1507 DRUID HILLS AVENUE – AFTER-THE-FACT WINDOW REPLACEMENT

(26-32-COA)

CITY OF HENDERSONVILLE - COMMUNITY DEVELOPMENT - HISTORIC PRESERVATION
COA STAFF REPORT

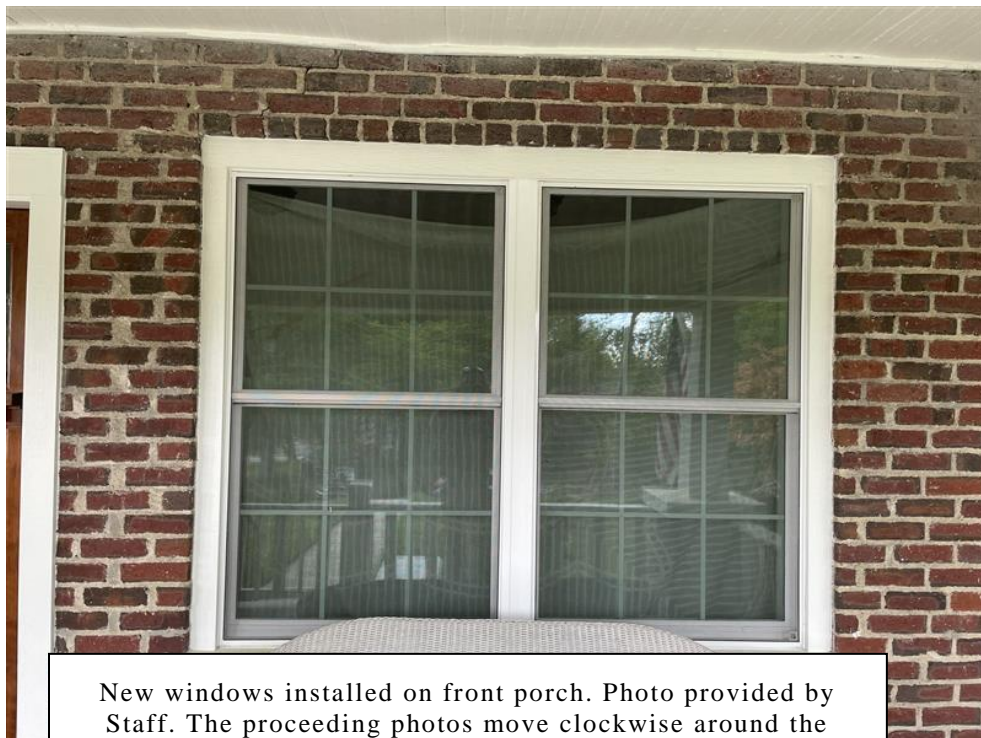
Photo taken from the Zillow listing from the home prior to current property owner. Photo show the previous windows that have been replaced. Photo dates from 2025.
Source: https://www.zillow.com/homedetails/1507-Druid-Hills-Ave-Hendersonville-NC-28791/51645596_zpid/

New windows installed on front porch. Photo provided by Staff. The proceeding photos move clockwise around the home and document all of the windows and doors.
